**SUBJECT: FORT CALHOUN STATION, UNIT 1 – ISSUANCE OF AMENDMENT RE:
REVISED TECHNICAL SPECIFICATIONS TO ALIGN TO THOSE
REQUIREMENTS FOR DECOMMISSIONING (CAC NO. MF9567;
EPID L-2017-LLA-0192)**

AMENDMENT TO RENEWED FACILITY OPERATING LICENSE

Amendment No. 297
Renewed License No. DPR-40

FIGURE 2-10

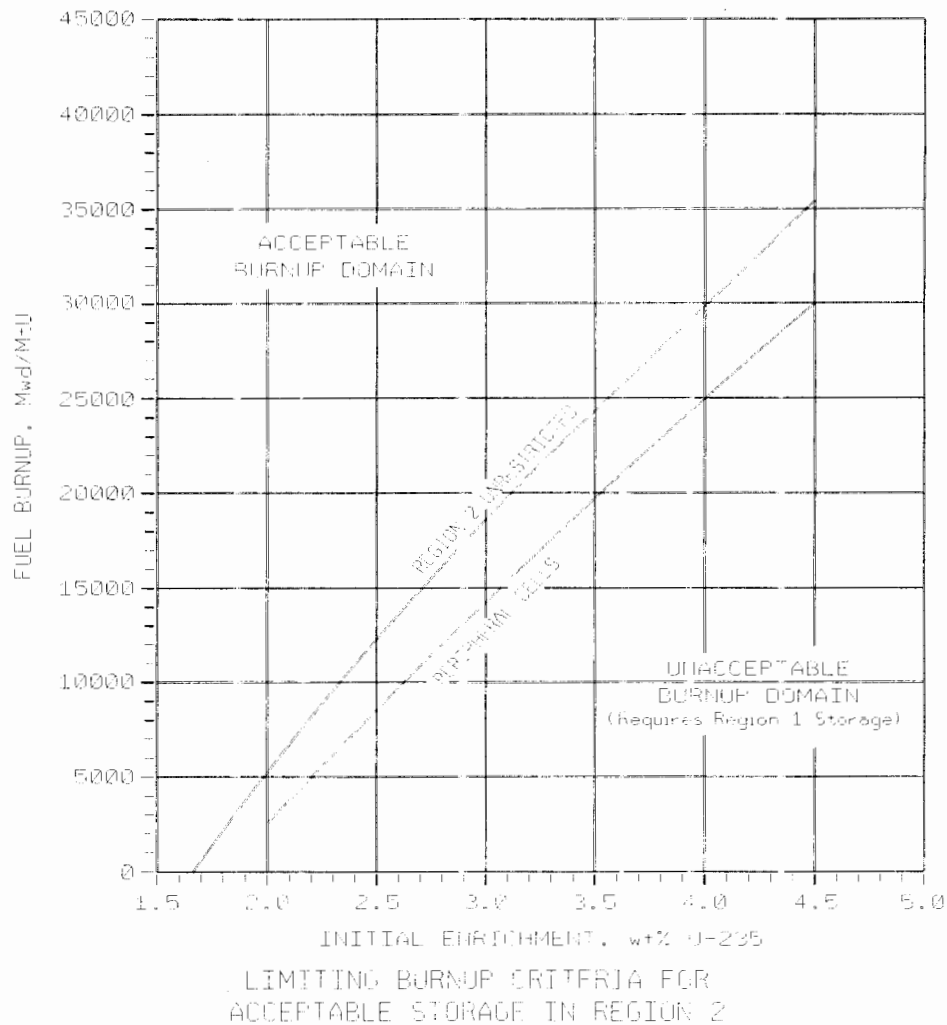
The combination of initial enrichment and burnup of each spent fuel assembly stored in Region 2 (including peripheral cells) of the spent fuel pool shall be within the acceptable burnup domain of Figure 2-10.

- e. Partially spent fuel assemblies with a discharge burnup in the "acceptable domain" of Figure 2-10 for "Region 2 Unrestricted" may be allowed unrestricted storage in any of the Region 2 fuel storage racks in compliance with Reference (1).

- f. Partially spent fuel assemblies with a discharge burnup between the "acceptable domain" and "Peripheral Cells" of Figure 2-10 may be allowed unrestricted storage in the peripheral cells of the Region 2 fuel storage racks in compliance with Reference (1).

- g. Partially spent fuel assemblies with a discharge burnup in the "unacceptable domain" of Figure 2-10 will be stored in Region 1 in compliance with Reference (1).
